File Number	PLPR-2408-0001		Contact	Jason Mozol, jmozol@duluthmn.gov	
Type	MU-C Planning Review		Planning Commission Date	October 8, 2024	
Deadline for Action	Application Date	August 28, 2024	60 Days	October 28, 2024	
	Date Extension Letter Mailed	October 2, 2024	120 Days	December 26, 2024	
Location of Subject	West Arrowhead Rd				
Applicant	Force 1 LLC		Contact	Jesse Carlson	
Agent	Titanium Partners		Contact		
Legal Description	010-1773-00020				
Site Visit Date	September 18, 2024		Sign Notice Date	September 24, 2024	
Neighbor Letter Date	September 19, 2024		Number of Letters Sent	7

Proposal

The applicant is proposing a new 4,000 square foot dental clinic on West Arrowhead Rd in a MU-C district. This project is phase 2 of Titanium's development of this site that included Bell Bank's new location completed earlier this year, which is adjacent to the dental clinic lot.

DENTIST OFFICE
DULUTH, MN

EXISTING CONDITIONS &
REMOVALS

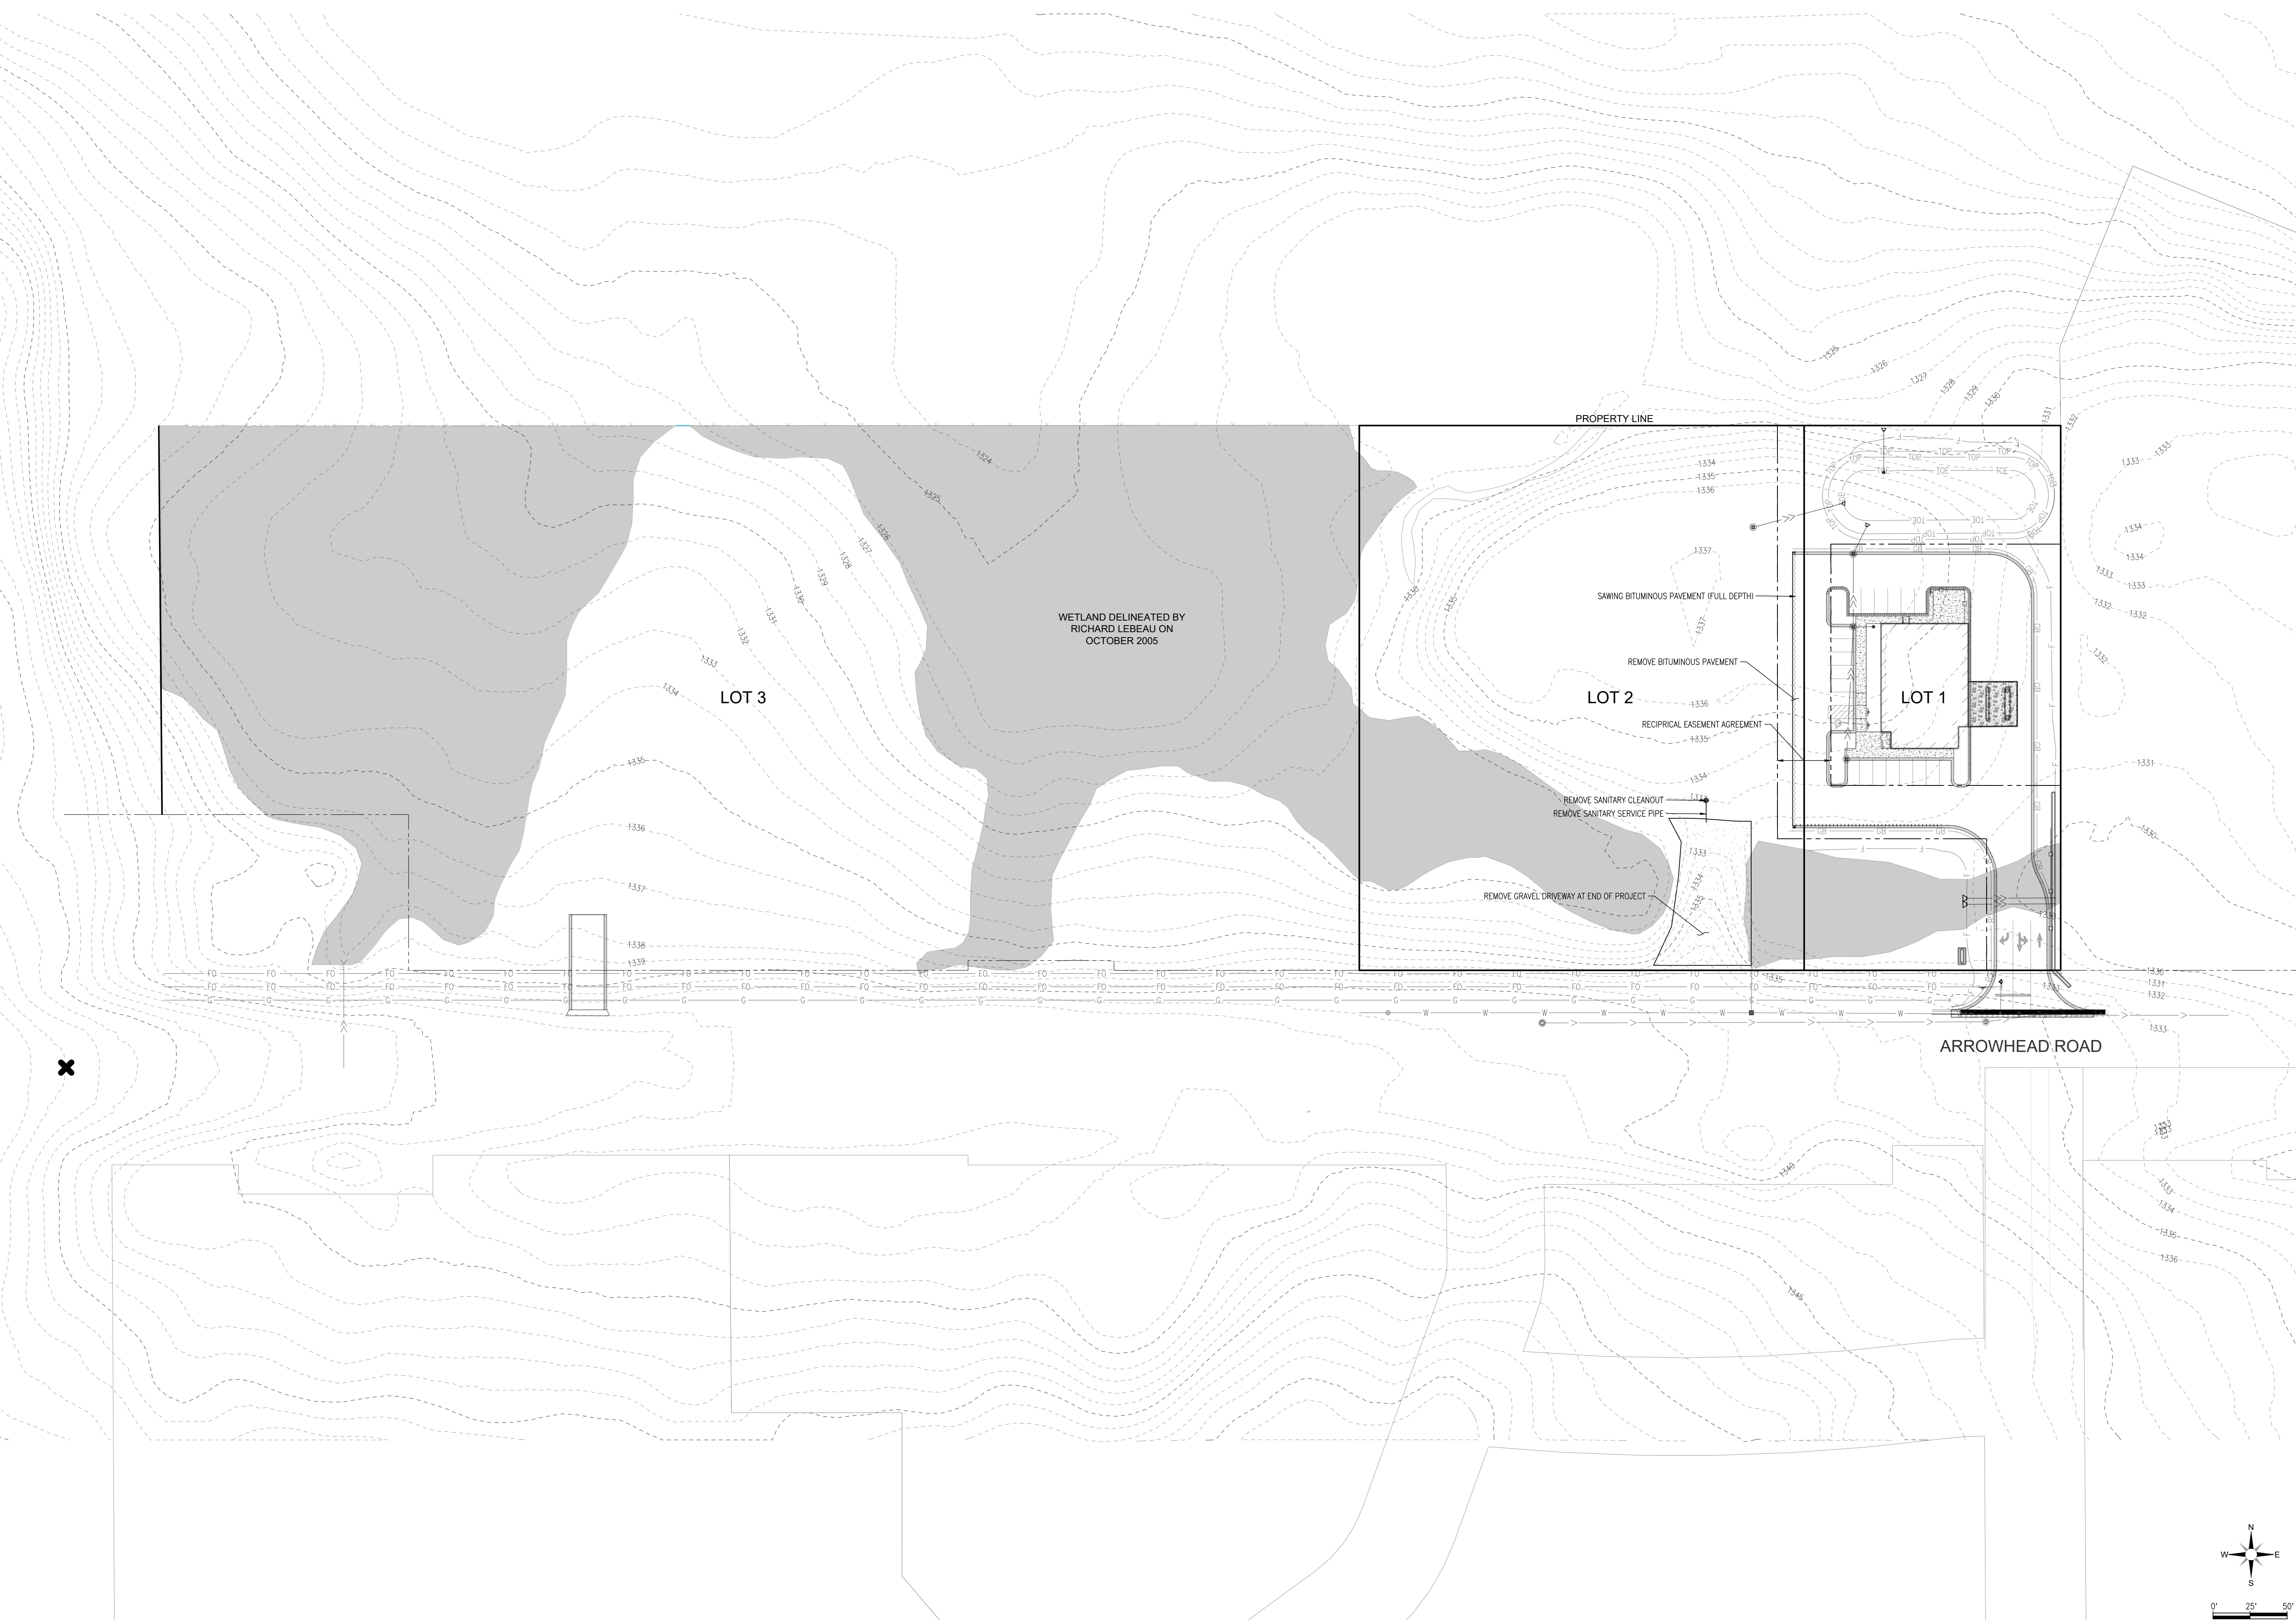
2. Sec 50-18.1.B (Wetlands)- The existing driveway goes through a wetland basin. The applicant has stated they intend to use this access during the construction process but will remove it afterwards. Staff recommends that the area is returned to natural grade after the project is complete and seeded with a wetland seed mix.

1. Applicant shall construct and maintain the project as identified in the attached exhibits.
2. Site grading and landscape plans must be submitted and approved by the Land Use Supervisor prior to building permit approval to include removal of the existing driveway to natural grade and seeding the area with an approved wetland seed mix.
3. The undeveloped area to the west of the proposed dental clinic must be seeded with a native plant mix prior to project completion.
4. An amended, compliant landscape plan be submitted and approved by the Land Use Supervisor prior to building permit approval.
5. Any alterations to the approved plans that do not alter major elements of the plan may be approved by the Land Use Supervisor without further Planning Commission approval; however, no such administrative approval shall constitute a variance from the provisions of Chapter 50.
